Re: Support Draft Bay Delta Conservation Plan (BDCP) and Associated  
Draft Environmental Impact Report/Environmental Impact Statement  
(EIR/EIS) Alternative #4

RE: City of Brentwood Comments to the Bay Delta Conservation Plan Draft  
EIR/EIS

**Re: Bay Delta Conservation Plan Draft EIR/EIS**

Re: Comments on Bay Delta Conservation Plan and Draft EIR/EIS

**Figure 1. Inflow to Trinity, Shasta, Oroville, and Folsom Reservoirs – NAA, NAA-ELT and NAA-LLT**

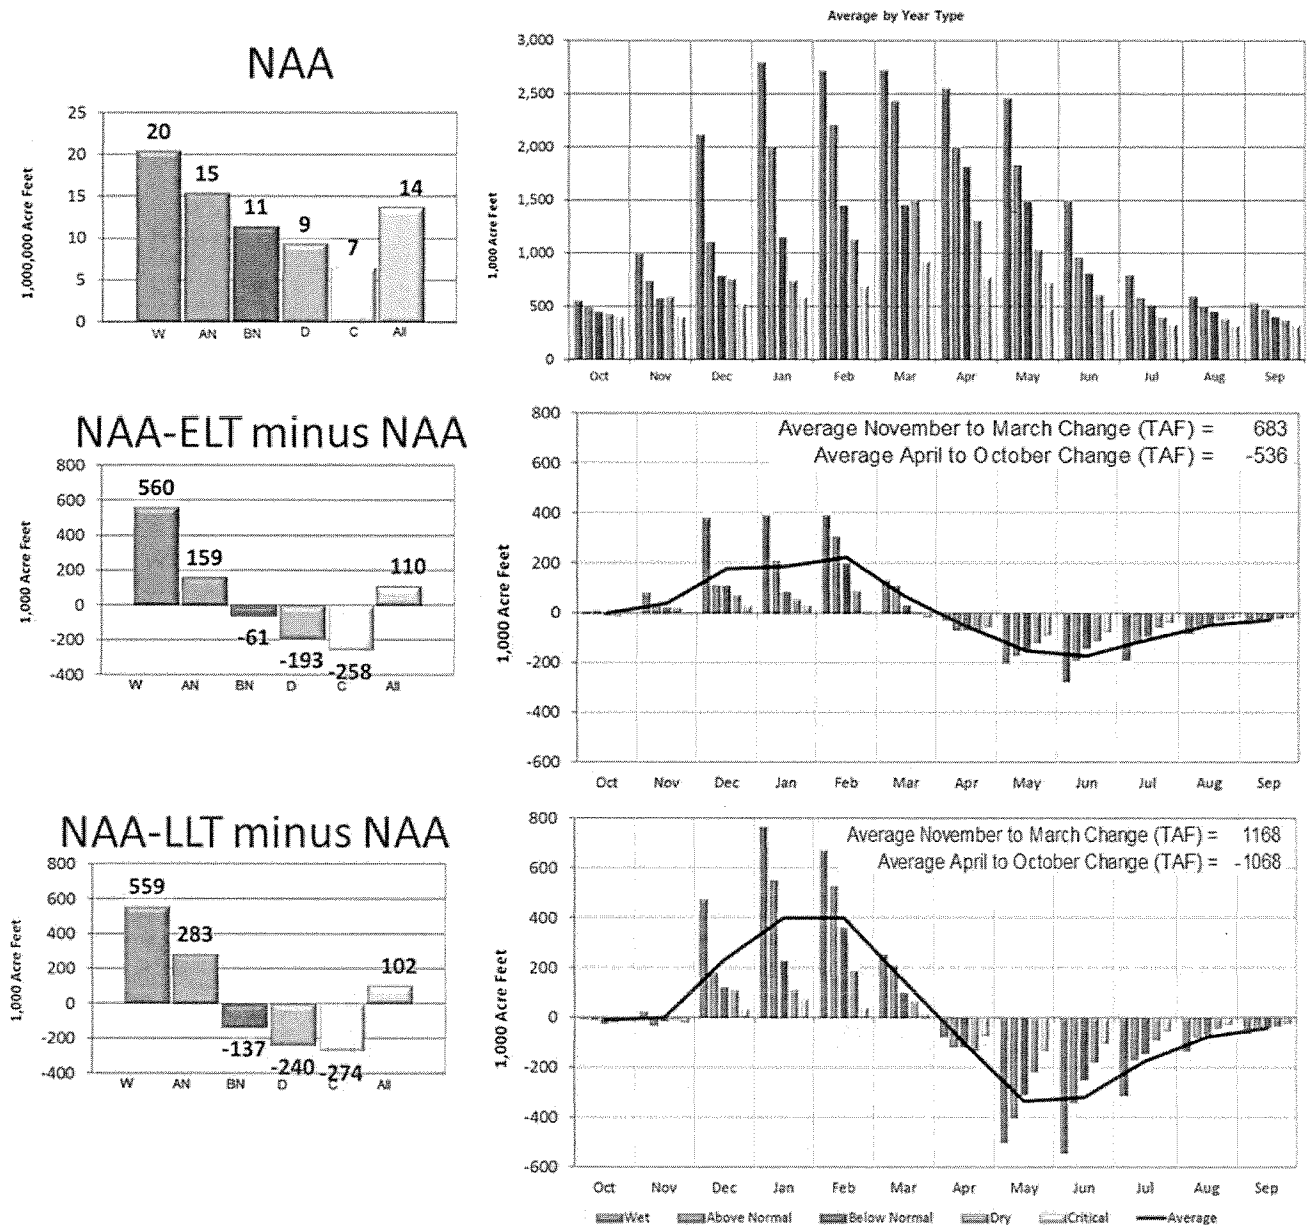
The significance of changed hydrology between the three without project baselines (NAA, NAA-ELT, and NAA-LLT) is illustrated below in Figure 1. The figure illustrates the projected combined inflow of Trinity, Shasta, Oroville, and Folsom Reservoirs under the NAA and the change relative to the NAA for the NAA-ELT and NAA-LLT baselines. BDCP baselines show Trinity, Shasta, and Oroville inflow are projected to increase overall, but with a significant shift from spring runoff to winter runoff and increases in wetter years with decreases in drier years.

Figure 1 show wetter conditions in wet years and drier conditions in dry years when considering the four basins together. However, climate change in the American River Basin for the LLT shows drier conditions in all year-types. Additionally, a large percentage of the dry and critical year inflow reduction, 57 and 37 percent respectively, for the combined four basins occur in the American River Basin. By comparison, runoff from the American River at Folsom is approximately 20 percent of the sum of runoff of the Trinity, Sacramento, Feather, and American rivers.

Figure 2. Projected Inflow to Folsom Reservoir – NAA, NAA-ELT and NAA-LLT

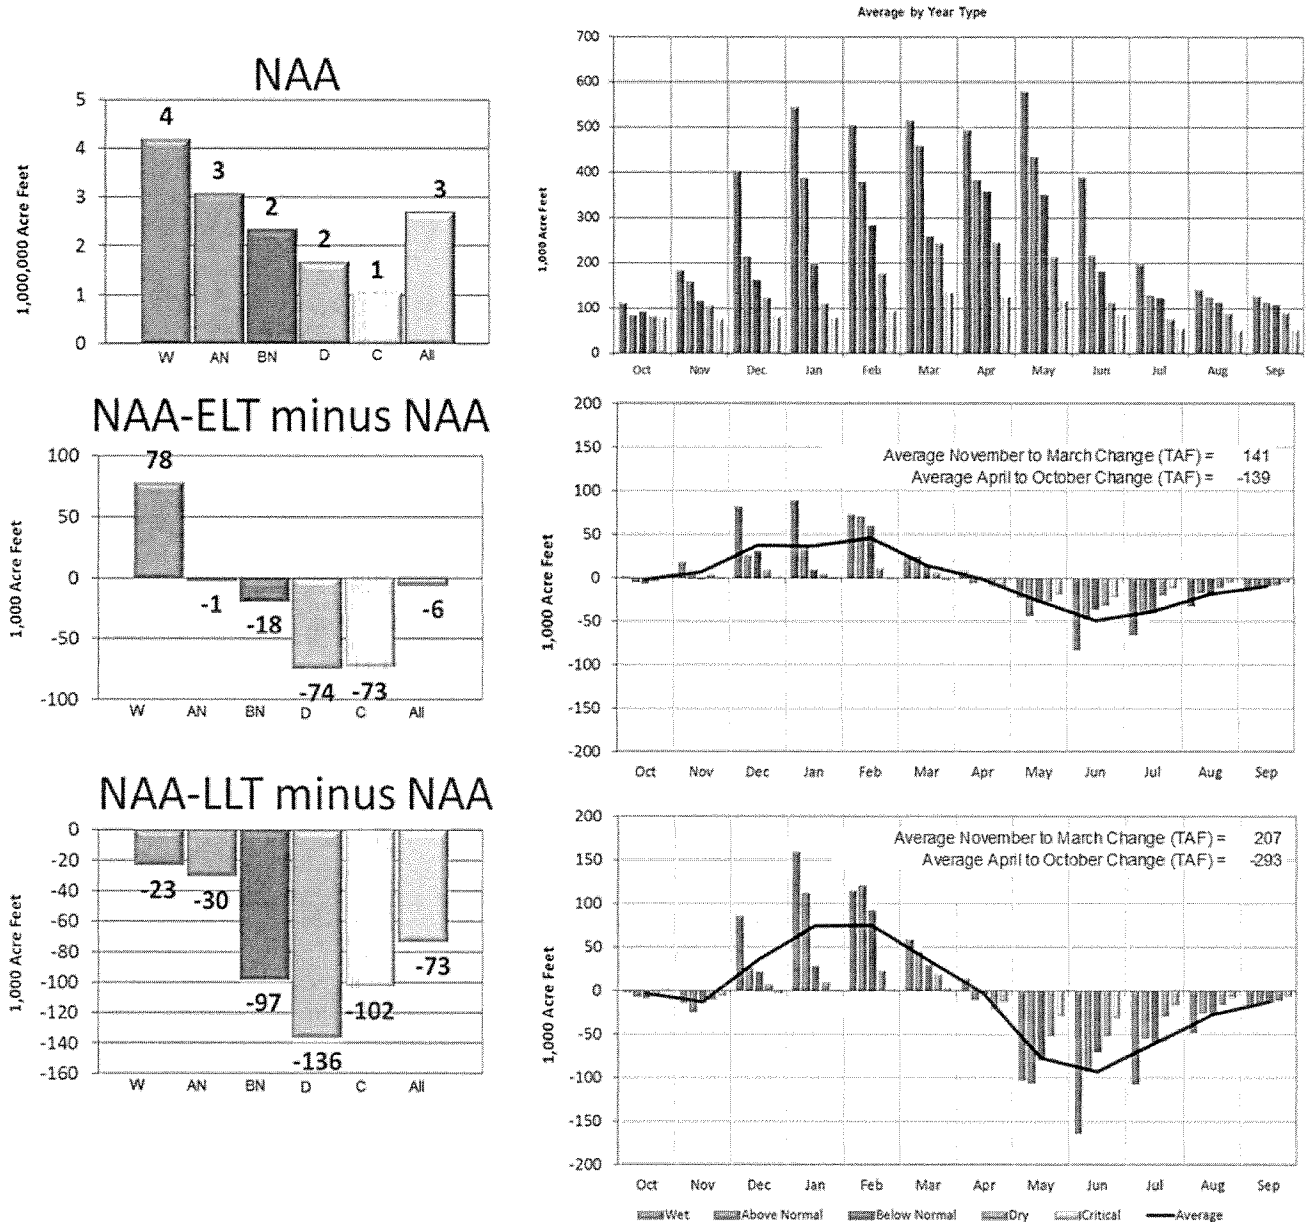
The effect of assumed climate change on average annual Folsom Reservoir inflow in the NAA-ELT scenario is minor, but causes decreases in inflow of about 70 TAF in the NAA-LLT scenario. The spring to winter shift in runoff is also projected for Folsom Reservoir inflow. Figure 2 is an illustration of Folsom inflow under the NAA and the change relative to NAA for the NAA-ELT and NAA-LLT baselines. To properly incorporate climate change into modeling of Folsom Reservoir and the American River, climate change effects must be applied to flows and reservoirs upstream from Folsom, which was not done. There is significant storage capacity in the upper American River watershed in PCWA's Middle Fork Project and the Sacramento Municipal Utility District's (SMUD) Upper American River Project. The

Comparison of inflow changes illustrated in Figure 1 and Figure 2 show the effects of climate change are large in the American River Basin relative to changes in other river basins. Total changes illustrated in

**Figure 3. Folsom Reservoir Carryover Storage**

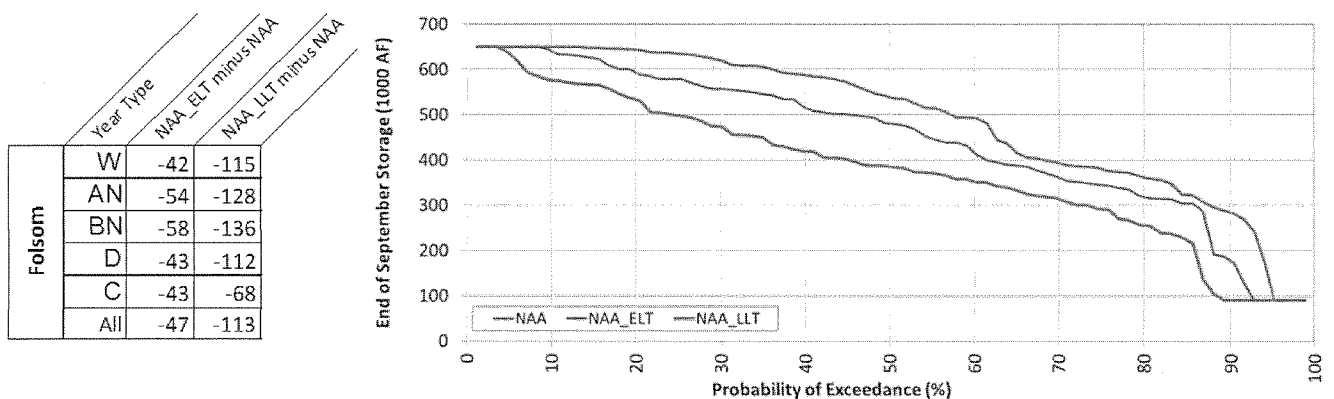
For Folsom and other upstream CVP and SWP reservoirs, the shift of in timing of inflows along with a continuing need to satisfy downstream environmental requirements and demands significantly affects carryover storage. Because of climate change's assumed effect on hydrology and the lack of CVP/SWP operational adaptations in the BDCP modeling, the CVP and SWP simply cannot satisfy water demands and regulatory criteria imposed on them in the NAA-ELT and NAA-LLT modeling scenarios. Figure 3 illustrates change in carryover storage in Folsom Reservoir. The relatively high frequency (approximately 10% of time) of minimum storage occurring at Folsom Reservoir leads us to question whether the NAAs reflect credible or defensible operations. The projected occurrences of low and dead storage conditions projected by the BDCP modeling result in severe reduction of flow available to sustain habitat in the Lower American River and severe reductions in water supply reliability.

**Figure 4. CVP North of Delta M&I Water Service Contract Allocation**

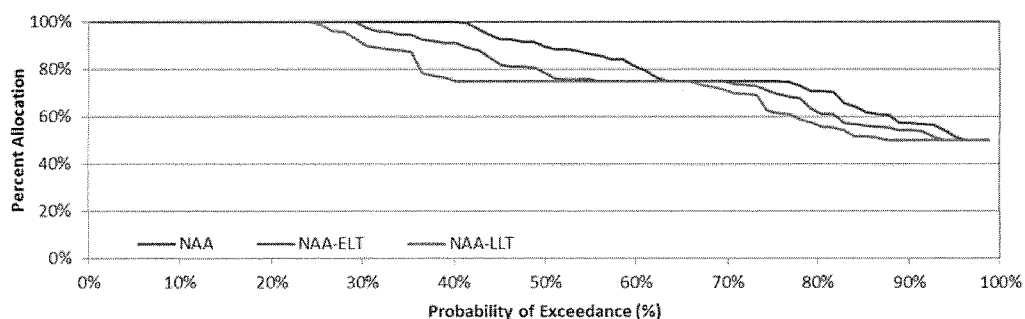
Assumed effects of climate change and lack of adaptation reduces CVP water supply allocations to American River CVP Water Service Contractors. Figure 4 contains exceedance probability plots of CVP M&I allocations for the NAA, NAA-ELT, and NAA-LLT scenarios. Full allocations are made 40% of the time under the NAA, this is reduced to about 30% in the NAA-ELT, and full allocations are made about 25% of the time in the NAA-LLT. The occurrence of 50% allocation increases from about 4% in the NAA to about 7% in the NAA-ELT and to about 12% in the NAA-LLT. In addition to reduced water service contract allocations, water supply allocations under any right cannot be satisfied due to low storage levels in Folsom Reservoir and low flow in the Lower American River. It is not physically possible to divert water for M&I use from Folsom Reservoir when reservoir storage drops below about 100,000 acre-feet because, at that level, the M&I intake in the reservoir would be dry. In addition, flows in the lower American River below about 500 cfs make it impossible for the City of Sacramento to divert water at its Fairbairn diversion. The water-supply and other effects of these physical conditions occurring in the NAA scenarios are not identified or evaluated in the draft BDCP EIR/EIS.

Figure 5. NAA-LLT and Alt 4-LLT Simulated Folsom Reservoir Elevation

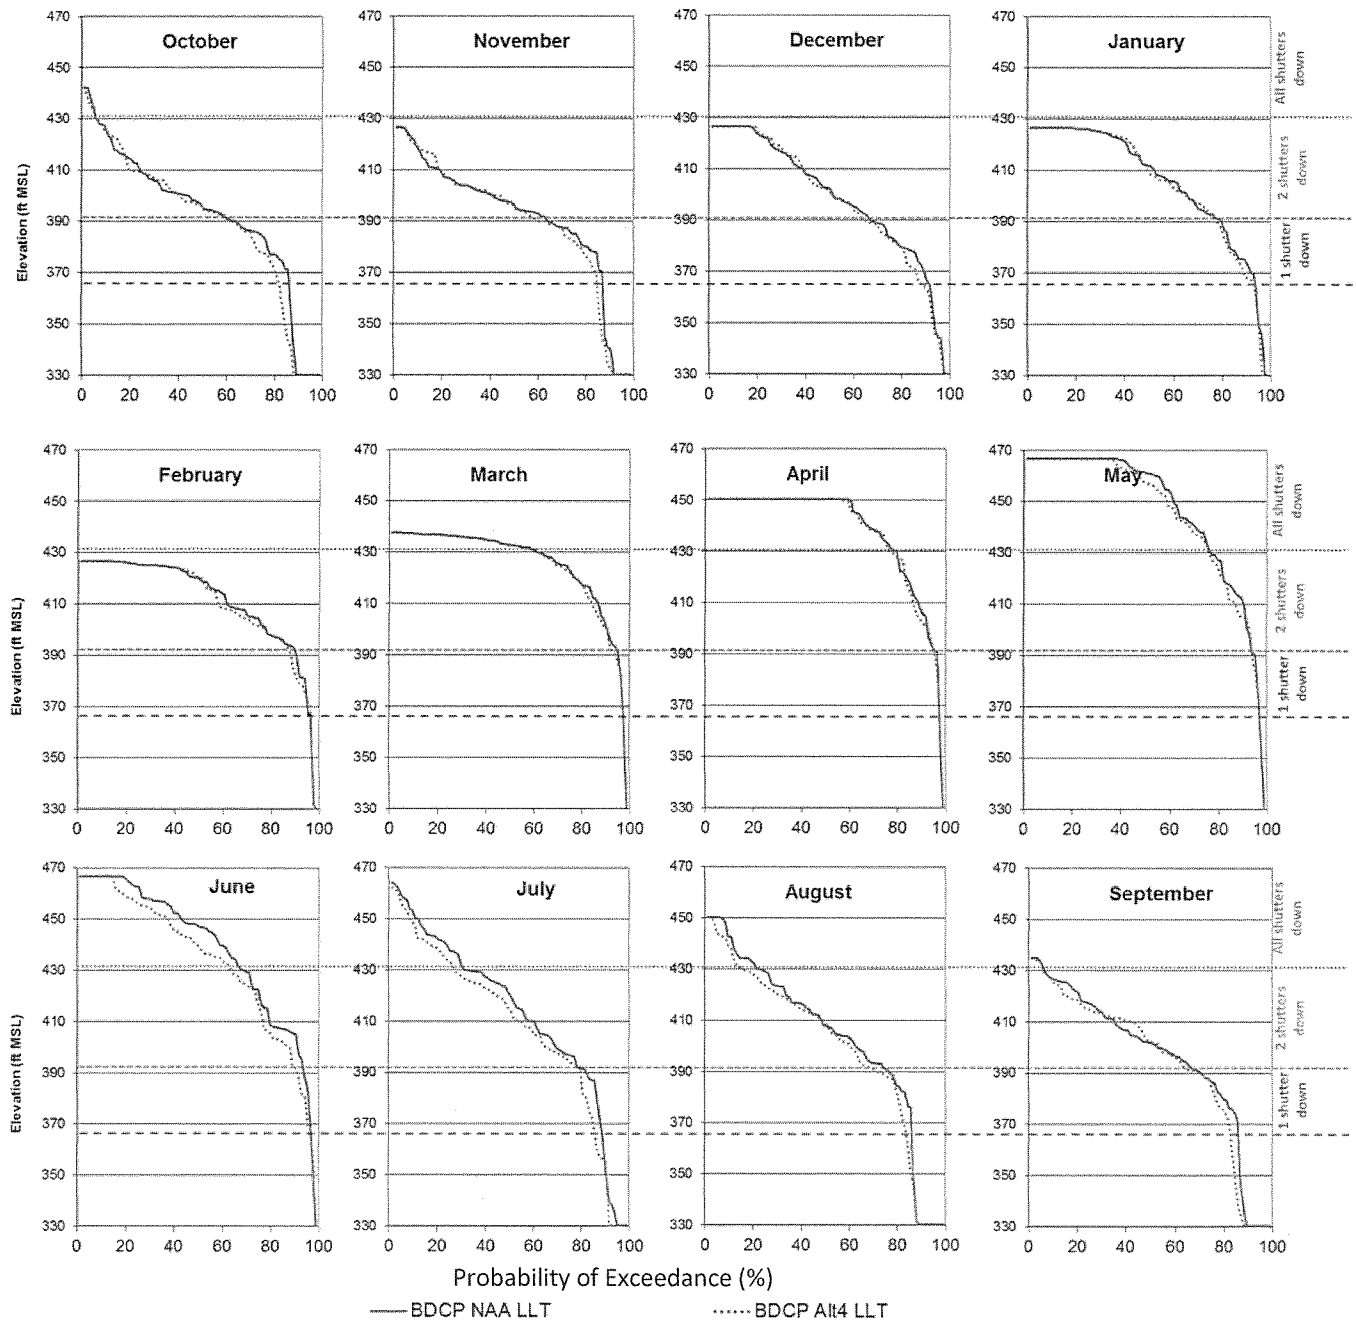
Figure 5 is a comparison of simulated monthly Folsom Reservoir water surface elevations for the baseline and with-Project scenarios. A probability of exceedance chart for each month illustrates differences between the two model simulations and potential Project effects. Dashed horizontal lines indicate water surface elevations when groups of shutters on the intake device must be removed. For example, when the water surface elevation goes below approximately 430 feet, the first group of shutters must be removed. These lines are 30 feet above the top of shutter elevations for the three groups of shutters to account for water depth to prevent the formation of a vortex and cavitation at the intake which would prevent diversion.

Results presented in Figure 5 illustrate that Folsom Reservoir water surface elevation is lower under the with-Project scenario. The largest difference in Folsom elevation occurs from June through August and can affect temperature management by changing when shutters are removed. Shutters are removed from Folsom Dam's intakes in order to access colder water located lower in the reservoir. While removing shutters causes the temperature of water diverted and released from the reservoir to drop almost immediately, that effect does not cause release temperatures to remain cooler indefinitely. Accordingly shutters must be removed strategically.

Figure 6. NAA-LLT and Alt 4-LLT Simulated Folsom Reservoir Storage

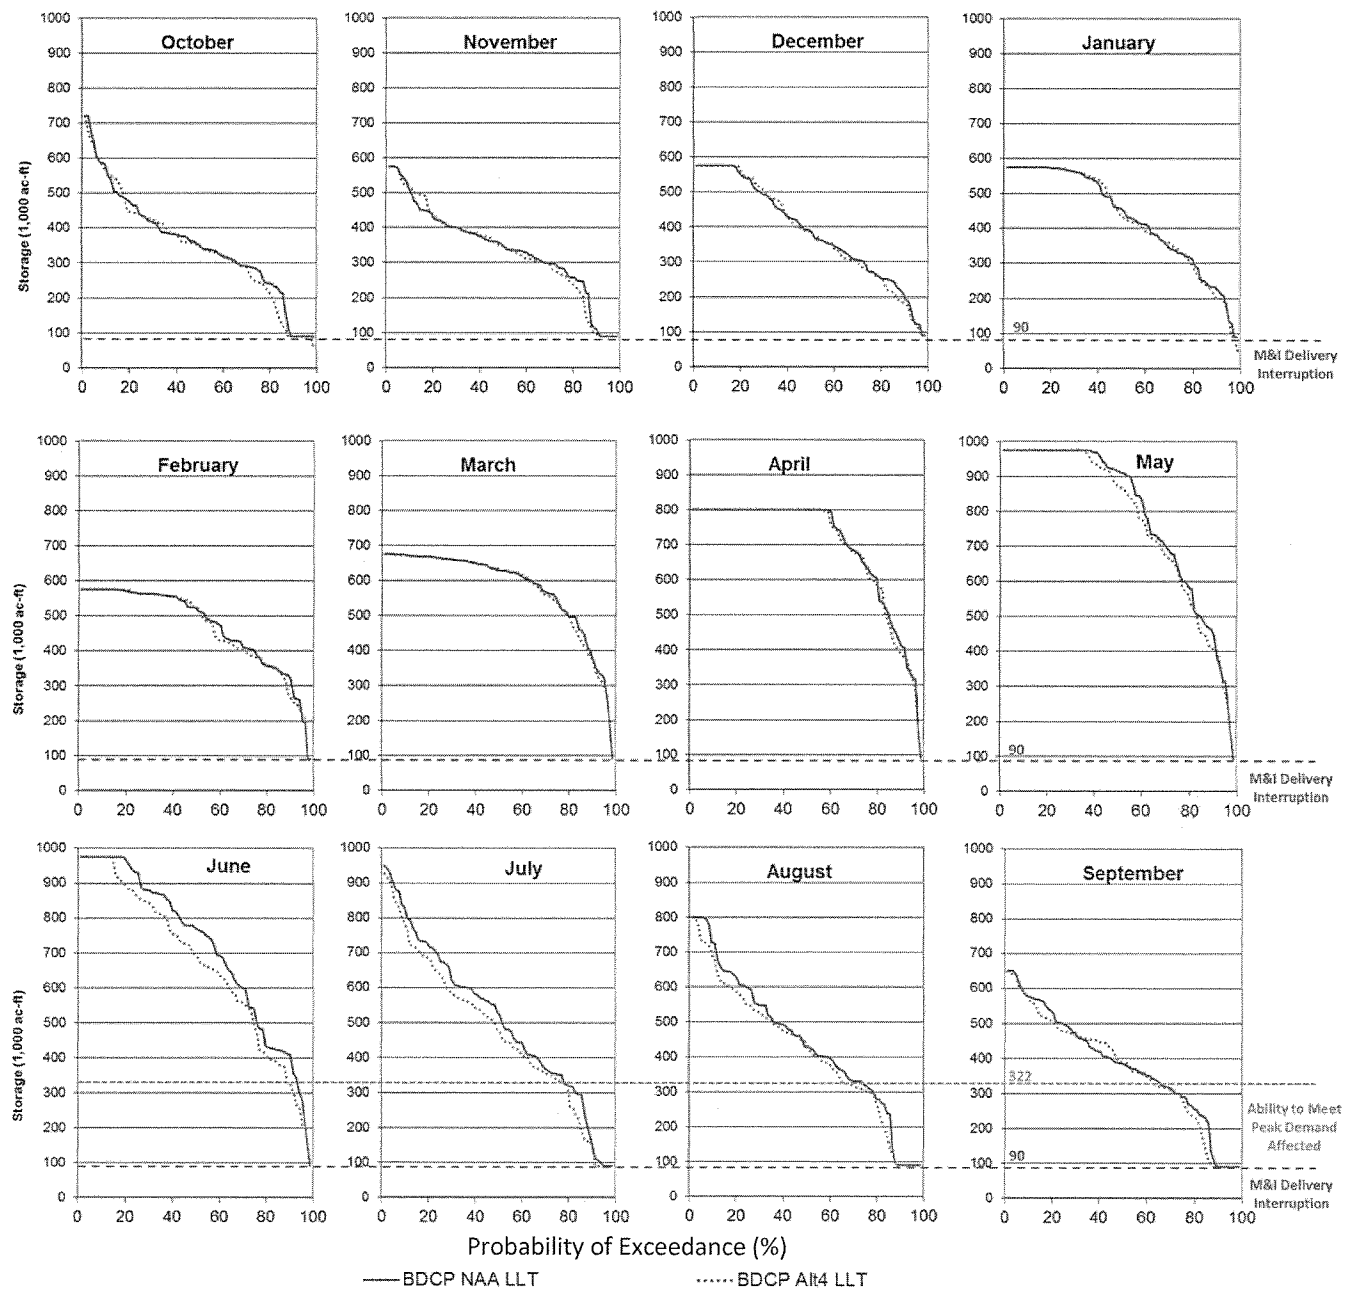
The timing of shutter removal at Folsom Reservoir would change in the with-project condition. For example, in August the probability of all three shutters being in use is reduced from approximately 25 percent to 15 percent, and the probability of at least one shutter still in used is reduced from approximately 90 percent to 85 percent. Figure 6 is a comparison of simulated monthly Folsom

Reservoir storage for the baseline and with-Project scenarios. A probability of exceedance chart for each month illustrates differences between the two model simulations and potential Project effects. Dashed horizontal lines in Figure 6 represent storage levels below which M&I water purveyors cannot meet peak demands (322 TAF) with diversions from Folsom (illustrated for peak demand months only) or when M&I diversions are interrupted because water levels in Folsom are below the M&I intake (90 TAF). Results summarized in Figure 6 show that Folsom Reservoir storage is more likely to be lower under the BDCP Alt4-LLT than the NAA-LLT particularly in peak summer months. Lower storage impacts the ability of the water purveyors that divert directly from Folsom Reservoir, as well as downstream purveyors on the American River, to meet peak demands in the summer and increases the probability of M&I delivery interruptions.
